Subject: FW: Landmark Trees - Oakhurst Rise 20/00683/OUT
Attachments: 2020-06-04 LANDMARK TREES PROPOSED LOCATION V2.pdf

Land off Oakhurst Rise Landscape Strategy

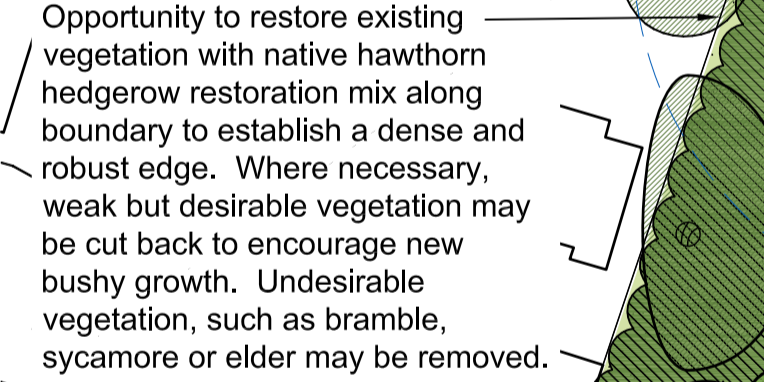
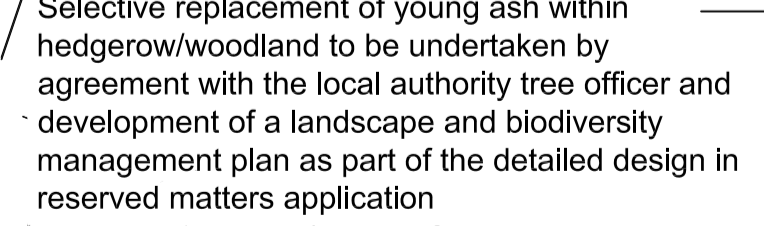
I have been asked to provide you with a quick mark-up sketch of the Oakhurst Rise site (20/00683/OUT) and in particular the land to the east where Chris Chavasse in his comments on the scheme has suggested that we plant some landmark trees as part of the development. I understand that there are heritage constraints in this area so provide the attached for your comment in relation to the proposed location of these trees. These are likely to be a species which will reach significant height over decades but will remain narrow in form rather than broad spreading. I have indicated the group further up the slope towards the eastern boundary, outside of vistas/views between heritage assets – marked in red.

Before we amend our landscape strategy proposals drawing can you confirm you are happy with the proposed location for a group of trees from a heritage perspective so that amendments to the scheme are in alignment across disciplines.

Thank you for your email. I have had an opportunity to consider the submitted plan showing the proposed location of limited additional tree planting. My initial opinion is that this amendment to the landscaping may be acceptable. However, it is difficult to comment with certainty as I consider a site visit will be necessary to assess the impact on views and openness to and from the listed buildings to gain a proper understanding of how their settings will be affected.

I suggest any formal amendment to the landscaping is not implemented until there has been an opportunity to do a site visit and give more definitive advice.
